PROJECT: LAND WEST OF CRAWLEY DOWN

Stage 1 Road Safety Audit

Proposed Site Access Arrangements onto Turners Hill Road

Report Ref: 22042-3

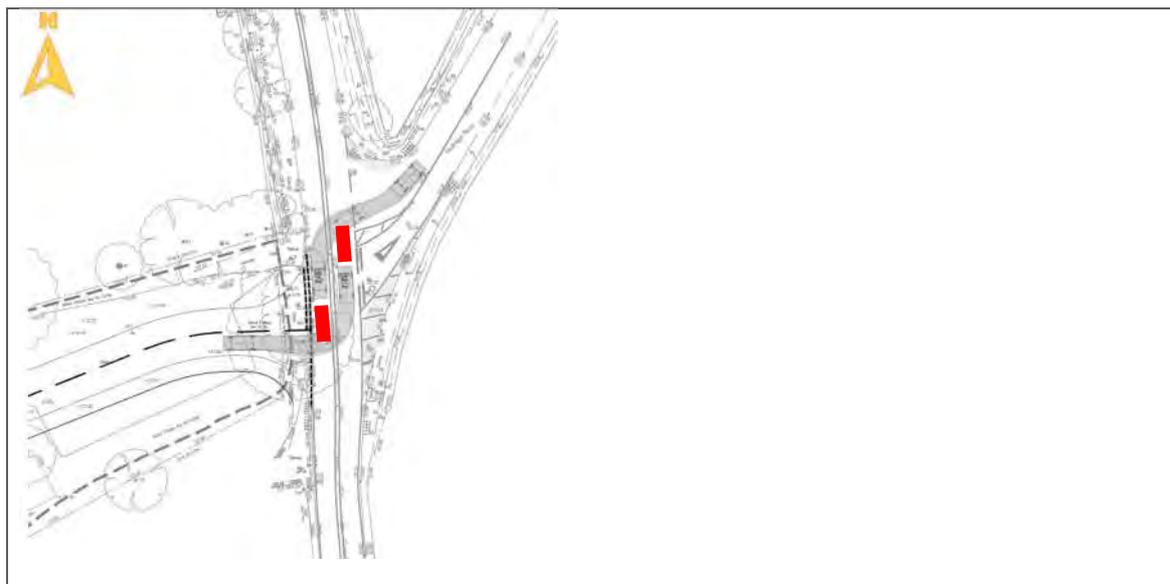
4.3.4	Problem
Location:	Turners Hill Road – Proposed Access
Summary:	Traffic queuing back from the minor arms will restrict turning manoeuvres at the minor arms
<p>Turners Hill Road is a single carriageway two-way road that is subject to a 30mph speed limit in the vicinity of the scheme. The scheme includes the provision of a new simple priority access on the western side of Turners Hill Road. The scheme includes the provision of a new simple priority access on the western side of Turners Hill Road, forming a left / right stagger junction arrangement with Vicarage Road. Following the potential implementation of the proposed scheme, should a queue of approximately two vehicles be observed, vehicles would be prevented from manoeuvring into the proposed access / Vicarage Road, which could lead to rear impact as well as sideswipe type collisions.</p>	
Recommendation:	
<p>It is recommended that 'keep clear' markings are provided where necessary in both the northbound and southbound lanes to ensure queuing traffic does not block vehicles attempting to turn right.</p>

<p>4.3.4 Following the potential implementation of the proposed scheme, should a queue of approximately two vehicles be observed, vehicles would be prevented from manoeuvring into the proposed access / Vicarage Road, which could lead to rear impact as well as sideswipe type collisions.</p>	<p>It is recommended that 'keep clear' markings are provided where necessary in both the northbound and southbound lanes to ensure queuing traffic does not block vehicles attempting to turn right.</p>	<p>Accepted – 'KEEP CLEAR' road markings have been added to Drawing ITB9155-GA-029I in both northbound and southbound lanes.</p>

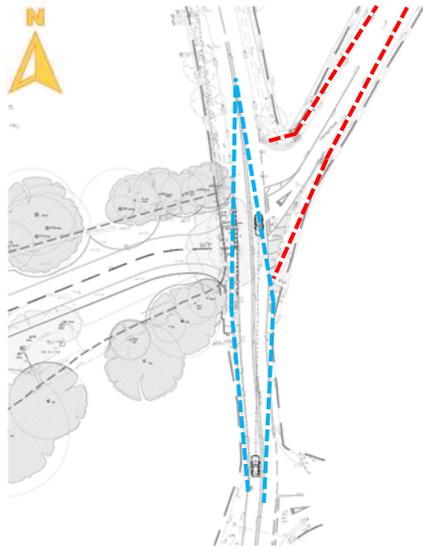
4.4	NON-MOTORISED USER PROVISION
4.4.1	Problem
Location:	Proposed Uncontrolled Crossing Points
Summary:	Insufficient visibility to / from users at the uncontrolled crossing points
<p>Turners Hill Road is a single carriageway two-way road that is subject to a 30mph speed limit in the vicinity of the scheme, with an existing uncontrolled pedestrian crossing present on the southern radius of Vicarage Road within the vicinity of the scheme. The scheme includes the provision of a new simple priority access on the western side of Turners Hill Road, the provision of a new uncontrolled crossing on Vicarage Road and the re-provision of the uncontrolled pedestrian crossing on Vicarage Road, south of its existing location. The Audit Brief identifies visibility splays of 38.3 metres on Vicarage Road and 61.7 metres and 49.9 metres to the north and south on Turners Hill Road respectively, however, no visibility splays have been shown for users at the crossing points on these arms. The Audit Team are unsure if suitable visibility is achievable from the crossing points, particularly on Vicarage Road where visibility appears restricted by the vegetation, bridge parapets and guard railing. Limited visibility from and to a crossing point could lead to a pedestrian / cyclist entering into the path of an approaching vehicle, resulting in a vehicle to pedestrian / cyclist collision or heavy vehicle braking and loss of control.</p>

Recommendation:	
<p>It is recommended that sufficient visibility to / from the crossing points is achievable and that any obstructions, to include vegetation and street furniture, within the visibility splay envelopes are cleared, and maintained clear, to ensure an appropriate level of visibility is achievable.</p>

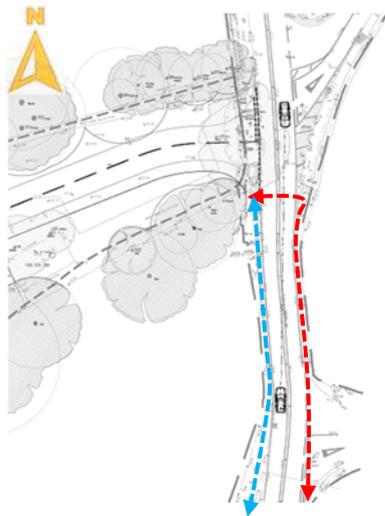
4.4.2

Turners Hill Road

Insufficient facilities for footway users along a likely desire line

Turners Hill Road is a single carriageway two-way road that is subject to a 30mph speed limit in the vicinity of the scheme. A footway is present on the eastern side of Turners Hill Road, with the closest bus stops located on Turners Hill Road, some 100 metres to the south and some 800 metres north. The scheme includes the provision of a new simple priority access on the western side of Turners Hill Road. A desire line will be present southbound to / from the closest bus stops, where a post box is also present on the western side of Turners Hill Road. While a proposed controlled crossing is illustrated to the south on Turners Hill Road, a lack of crossing facilities at the Turners Hill Road / Grange Road junction and at the bus stops could lead to pedestrians continuing via the narrow footway over the bridge and the grass verge on the western side of Turners Hill Road. If opposed by other users a pedestrian could enter the live carriageway where vehicles are manoeuvring, potentially into the path of vehicles, resulting in vehicle to pedestrian collisions.

It is recommended that measures are provided to discourage pedestrians from continuing southbound via the narrow footway over the bridge and grass verge on the western side of Turners Hill Road and that suitable facilities are provided at the Turners Hill Road / Grange Road junction and at the northbound bus stop to encourage pedestrians to navigate via the existing footway on the eastern side of Turners Hill Road.

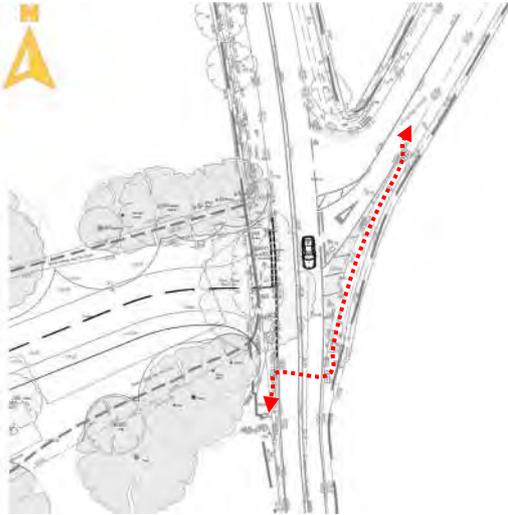
4.4.3

Turners Hill Road / Vicarage Road

Insufficient facilities to accommodate pedestrians and cyclists along a likely desire line

Turners Hill Road and Vicarage Road are single carriageway two-way roads that are subject to a 30mph speed limit in the vicinity of the scheme. Footways are present on the eastern side of Turners Hill Road and the northern side of Vicarage Road. The scheme includes the provision of a new simple priority access on the western side of Turners Hill Road and two uncontrolled pedestrian crossings on Vicarage Road and Turners Hill Road. Cyclists travelling between the northeast / centre of Crawley Down and the Worthy Way footpath and bridleway, are likely to utilise the dropped kerbs associated with the proposed crossing on Vicarage Road, travel along the footway and utilise the proposed crossing on Turners Hill Road, within the vicinity of the entrance / exit to Worthy Way. There is a concern the existing footway and the proposed uncontrolled crossings are insufficient to accommodate both cyclists and pedestrians that can be expected to utilise them. An inadequate width footway and uncontrolled crossings could lead to cyclist to pedestrian collisions or pedestrians / cyclists attempting to enter / exit the footway where full height kerbs are present, which could destabilise a cyclist, leading to a fall and personal injury or potentially vehicle to cyclist collisions and pedestrian trips and falls or potentially vehicle to pedestrian collisions.

It is recommended that dedicated cycle on and off-slips, with associated giveaway markings, are provided where appropriate, that the footway is suitable to accommodate pedestrians and cyclists, that the proposed uncontrolled pedestrian crossing on Turners Hill Road is also suitable to accommodate pedestrians and cyclists and that advance warning, to include hazard warning paving, are provided.

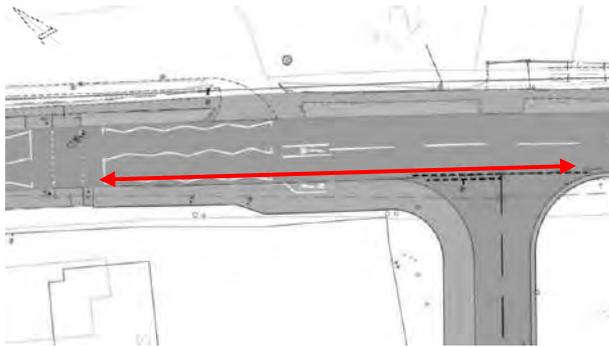
A.1	<p>LOCAL ALIGNMENT</p> <p><i>No Road Safety Concerns regarding LOCAL ALIGNMENT have been raised at this stage.</i></p>
A.2	GENERAL
A.2.1	PROBLEM
Location:	Turners Hill Road
Summary:	Provision of the proposed footway and associated kerbing will impact surface water drainage
Acc Type:	Loss of control type collisions
<p>The B2802 Turners Hill Road in Crawley Down benefits from a network of road gullies together with the section of verge abutting the carriageway, cater for surface water. The proposals include the provision of a priority access off the western side of the carriageway as well as a section of footway to link to the existing footway network to the north. Whilst the proposals should not have an adverse impact on the existing contours of the carriageway, the provision of kerbing alongside the proposed footway, will prevent the drainage of surface water through the existing soft verge. The Audit Team have concerns that the proposals could therefore result in excessive surface water ponding which may lead to loss of control type collisions.</p>

RECOMMENDATION:	
It is recommended that surface water is sufficiently drained from the carriageway.	
<p>Location Plan:</p>

RSA Problem	RSA Recommendation	Design Organisation Response	Overseeing Organisation Response	Agreed RSA Action
<p>A.2.1 The B2802 Turners Hill Road in Crawley Down benefits from a network of road gullies together with the section of verge abutting the carriageway, cater for surface water. The proposals include the provision of a priority access off the western side of the carriageway as well as a section of footway to link to the existing footway network to the north. Whilst the proposals should not have an adverse impact on the existing contours of the carriageway, the provision of kerbing alongside the proposed footway, will prevent the drainage of surface water through the soft verge. The Audit Team have concerns that the proposals could therefore result in excessive surface water ponding which may lead to loss of control type collisions.</p>	<p>It is recommended that surface water is sufficiently drained from the carriageway.</p>	<p>Accepted – drainage features and measures will be addressed at the detailed S278 design.</p>

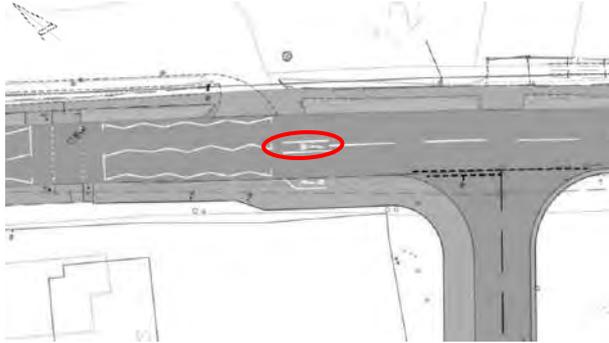
A.2.2	PROBLEM
Location:	Turners Hill Road
Summary:	Existing items of street furniture are present within the proposed footway
Acc Type:	Vehicle to pedestrian type collisions
<p>The B2802 Turners Hill Road accommodates both telegraph / electric poles and signs within the verges both sides of the carriageway. The proposals include the provision of a footway along the western side of the carriageway where both signage and telegraph / electric poles are present. It is understood that the Audit Brief identifies that signage and utilities are to be assessed through the detail design stage and it is clear that the sign will be relocated due to it being situated in the middle of the access, nevertheless, the Audit Team have concerns that the existing telegraph / electric pole will reduce the width of the footway and could result in the need for a user to suddenly enter the carriageway which could lead to a vehicle to pedestrian type collision.</p>

RECOMMENDATION:	
It is recommended that items of street furniture are relocated.	
Location Plan:

RSA Problem	RSA Recommendation	Design Organisation Response	Overseeing Organisation Response	Agreed RSA Action
<p>A.2.2 The B2028 Turners Hill Road accommodates both telegraph / electric poles and signs within the verges both sides of the carriageway. The proposals include the provision of a footway along the western side of the carriageway where both signage and telegraph / electric poles are present. It is understood that the Audit Brief identifies that signage and utilities are to be assessed through the detail design stage and it is clear that the sign will be relocated due to it being situated in the middle of the access, nevertheless, the Audit Team have concerns that the existing telegraph / electric pole will reduce the width of the footway and could result in the need for a user to suddenly enter the carriageway which could lead to a vehicle to pedestrian type collisions.</p>	<p>It is recommended that items of street furniture are relocated.</p>	<p>Accepted – Drawing ITB9155-GA-038G demonstrates that the telegraph pole will be relocated to the back of the footway where there is sufficient space to do so. The revised drawing aids this relocation because it shows a footway rather than cycleway in this location.</p>
